T ECHNICAL INFORMATION

71404

- Subject** ▶ Modification of Gear Housing Complete
- For Models** ▶ 6823, 6823TP
- Country** ▶ All countries
- Description** ▶ Gear housing complete has been modified as illustrated below.

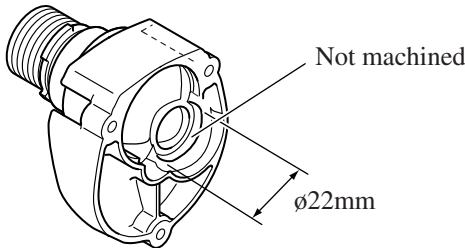
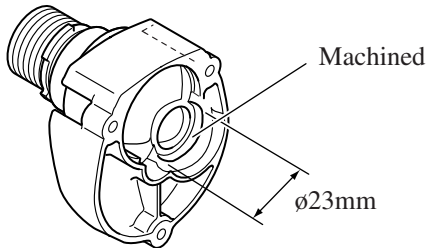
▶ Current	▶ New
 <p>Not machined</p> <p>ø22mm</p> <p>Gear Housing Complete (151719-5)</p>	 <p>Machined</p> <p>ø23mm</p> <p>Gear Housing Complete (154452-8)</p>

Item No.	Current part		Q'ty	I/C	New part		Q'ty	Note
007	Gear Housing Complete 151719-5		1	←	Gear Housing Complete 154452-8		1

The arrow ← means that the new part can be substituted for the current.
